Historic Landmarks and Preservation Districts Commission

Certificate of Appropriateness

Case No: 16COA1177-CL

Property Address: 189 N Bellaire Ave

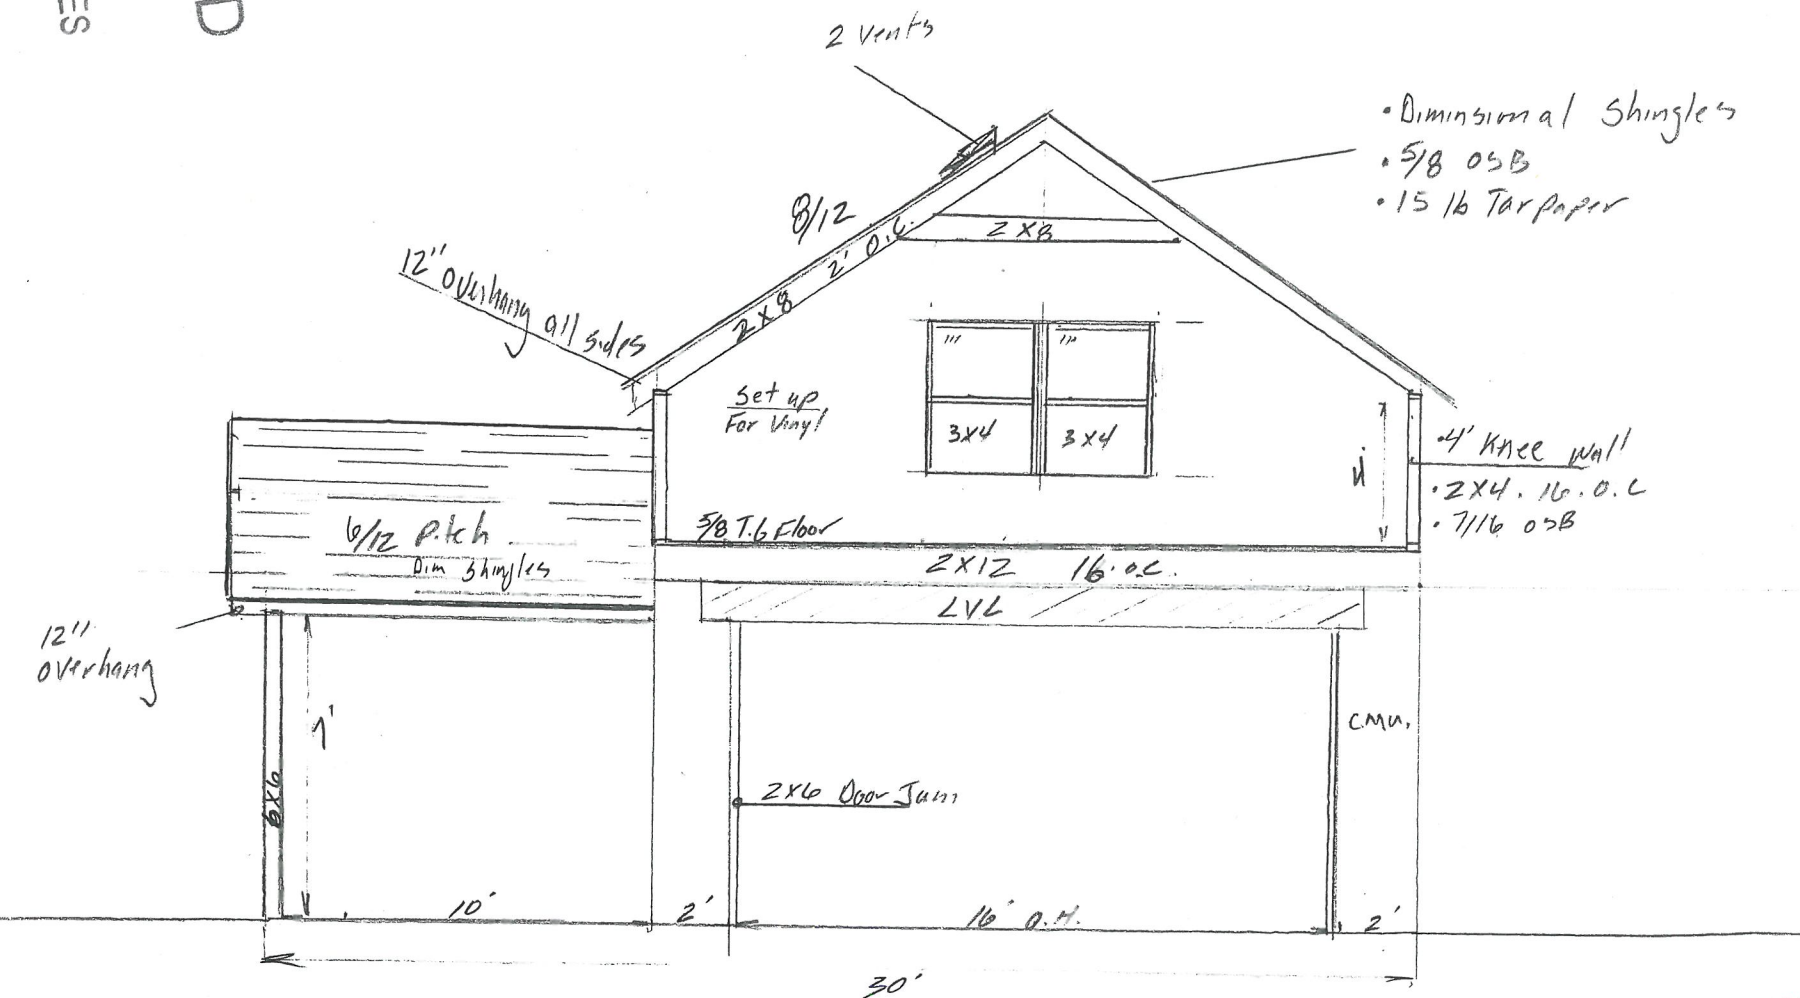
The applicant requests approval to remove the existing rear wood access deck and stairs in order to construct a new 17.75' wide by 15.48' deep one story wood framed screen-room with deck off of the first floor elevation on the back of the house. The screen-room will have a shed roof and wood deck with steps to access the back yard area. The existing rear door will serve as entry into the new screen-room. The proposal also includes the request to remove the second floor door which will be replaced with a standard one over one window to match the adjacent window. The remaining wall infill area below will be enclosed with vinyl siding to match the surrounding wall area.

- Set up For Vinyl Siding
- Set up For Aluminum Eave

1. Any exposed wood materials must be painted or stained with an opaque finish.
